Project	IEEE 802.16 Broadband Wireless Access Working Group < http://ieee802.org/16 >	
Title	Enhancements of the 4 transmit antenna rate 1 space-time code for the OFDMA PHY	
Date Submitted	2004-08-27	
Source(s)	Erik Lindskog, V. Shashidhar, B. Sundar Rajan, Djordje Tajkovic, Tareq Al Naffouri, Erik Stauffer, Taiwen Tang, David Garrett, K. Giridhar, Bob Lorenz, Babu Mandava, A. Paulraj, Trevor Pearman, Kamlesh Rath, Aditya Agrawal, Mai Vu	Voice: +1-408-387-5021 Fax: +1-408-496-0040 elindskog@beceem.com
	Beceem Communications, Inc. Freedom Circle, Suite 101 Santa Clara, CA 95054	
Re:	802.16e/D5	
Abstract	We propose improved space-time codes with full diversity for 4 Tx – Rate 1.	
Purpose	To propose enhancements of the space-time codes in 802.16e/D4.	
Notice	This document has been prepared to assist IEEE 802.16. It is offered as a basis for discussion and is not binding on the contributing individual(s) or organization(s). The material in this document is subject to change in form and content after further study. The contributor(s) reserve(s) the right to add, amend or withdraw material contained herein.

Enhancement of the 4 Transmit Antenna Rate 1 Space-Time Code for the OFDMA PHY

Figure 1: Performance comparison for 4Tx-Rate 1 the current matrix A in the standard and proposed matrix A₁ for Pedestrian-B channel model, QPSK modulation, and Tail-biting Convolutional Code with Hard Decision Decoding.

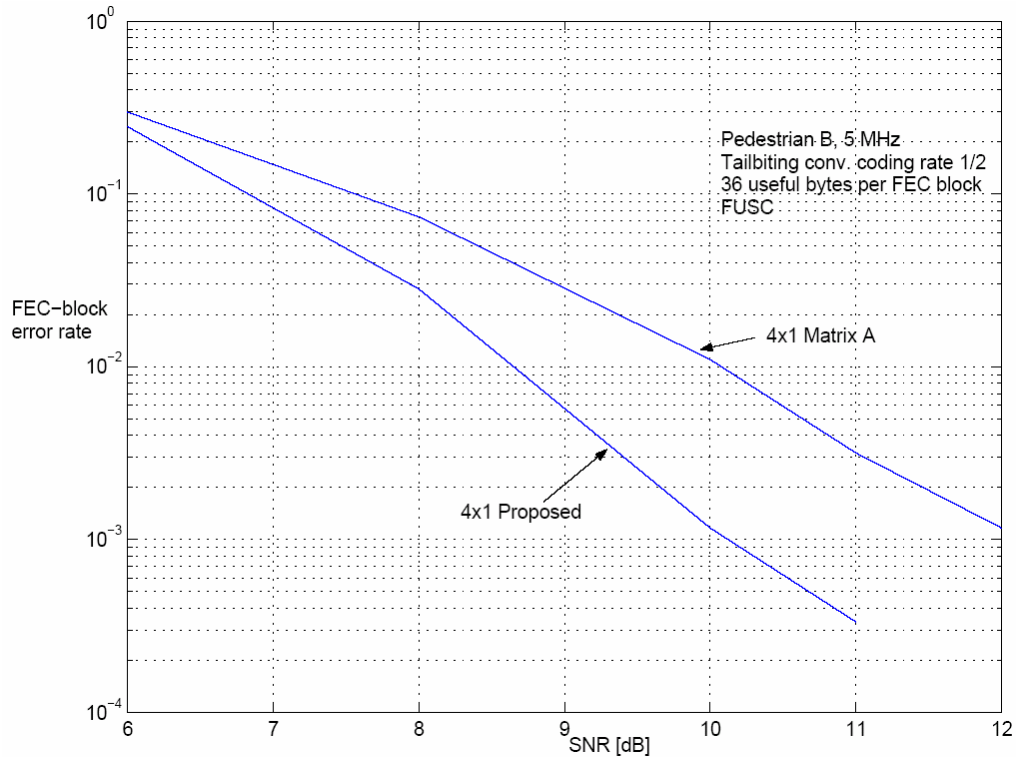
This proposed change is guided by the following reasons: (i) The transmit diversity gain of A_1 is 4 whereas that of A in [1] is only 2; (ii) A_1 admits a decoupled symbol-by-symbol decoding for the variables which leads to a fast ML decoding (analogous to the Alamouti code for 2Tx). Fig. 1 shows the performance of this code using decoupled ML decoding of low complexity for QPSK.
